EVALUATION OF HYDROGEOLOGIC ASPECTS OF PROPOSED  
SALINITY CONTROL PROGRAM IN PARADOX VALLEY, COLORADO

By L. F. Konikow and M. S. Bedinger

Open-File Report 78-27

This report, evaluation of the hydrogeological aspects of a plan to control salinity increases in the Dolores River where it crosses Paradox Valley in southwestern Colorado, was prepared at the request of the U.S. Bureau of Reclamation. The evaluations and recommendations presented in this report are based on data available to the authors in March 1975. The report has not been revised to reflect any additional information that has become available since then.

Figure 4.--Northwest-trending cross section through Paradox Valley showing possible configuration of flow field that has been affected by withdrawal of water from wells on both sides of the Dolores River. Note larger scale and shorter length of section in comparison with figure 2.

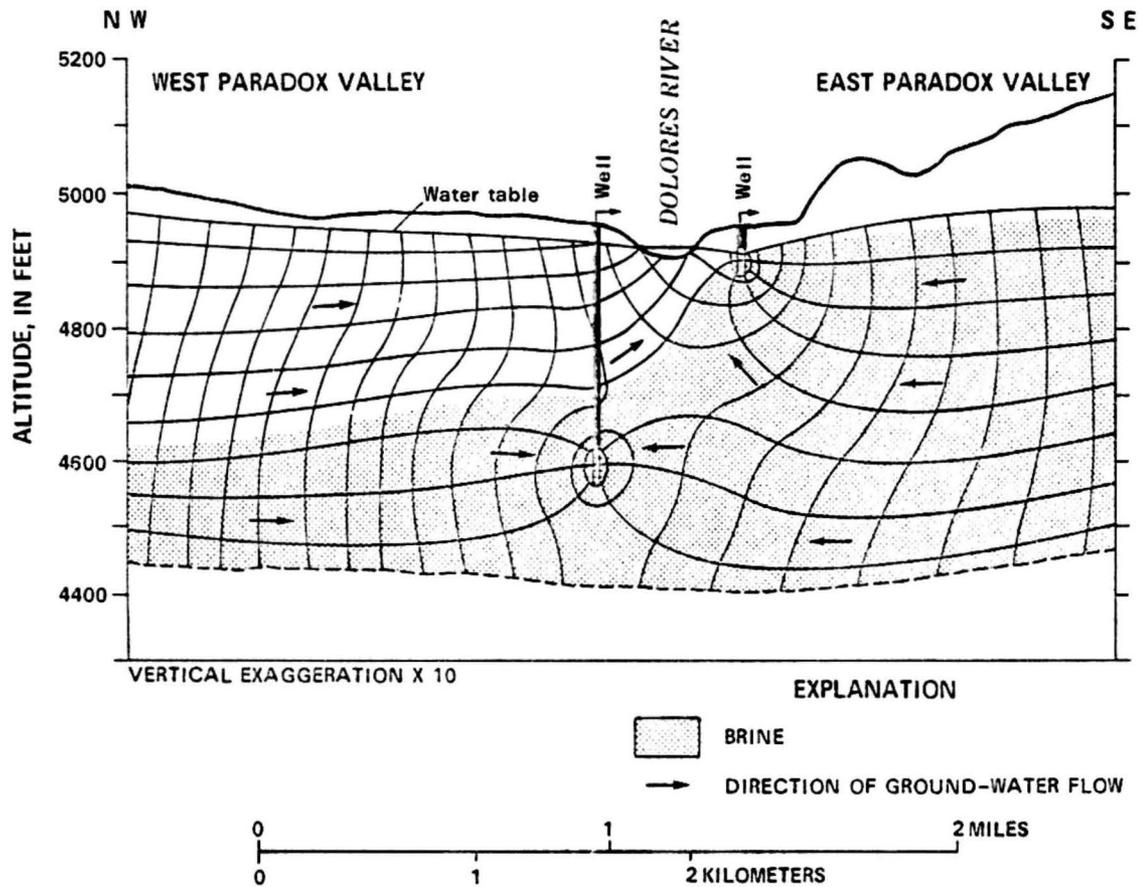
The well field should obviously be located close to the Dolores River within the area of surfacing brine. If field data confirm the concept shown in figure 2 that brine is discharging towards the river from both East and West Paradox Valleys, then it would seem logical for maximum capture that wells should be located on both sides of the river. Wells on the west side should pump from within a relatively deep interval (perhaps 200 to 400 ft), while wells on the east side should pump from a relatively shallow interval (perhaps 10 to 50 ft). If all wells were located on only one side of the river, either east or west, then to achieve complete capture of brine inflow on the opposite side of the river, the influence of pumping would have to offset and extend past the potential recharge effects of the river, which can act as a recharge boundary (or a partially penetrating line source) if the hydraulic gradient is significantly lowered beneath it after a long period of pumping. This then would require higher total pumping rates, higher flow velocities in the aquifer, more dispersion of dissolved salts into fresher ground water, and consequently the need to pump and dispose of a greater volume of brine at a reduced concentration to achieve the goal of removing 180,000 or more tons of salt per year. Figure 4 illustrates the predicted pattern of the flow field after being modified by the effects of pumping from wells on both sides of the river. Pumping rates would have to be carefully monitored and adjusted to minimize induced infiltration from the river. Pumping rates from the deeper wells on the west side of the river might have to be larger than from the shallow wells on the east side to produce a flow field similar to that shown in figure 4.

sinks passing through the two points of well diversion shown in figure 4 would offer an ideal solution to the real three-dimensional flow problem. In the field this can be approximated with two lines of closely spaced wells. Hydraulic interference between closely spaced pumping wells would minimize the risk that brine would surface in areas between wells. Having a large number of closely spaced wells would also (1) require a lower pumping rate in each well, thereby minimizing the percentage of fresh ground water that would be diverted; (2) allow greater flexibility to vary pumpage rates in individual wells in response to transient shifts in the position of the interface between freshwater and brine, thereby permitting more efficient operation and management of the system; and (3) allow individual wells to be temporarily shut down for routine maintenance or emergency repairs with a minimal reduction in the operational effectiveness of the salinity-control program.
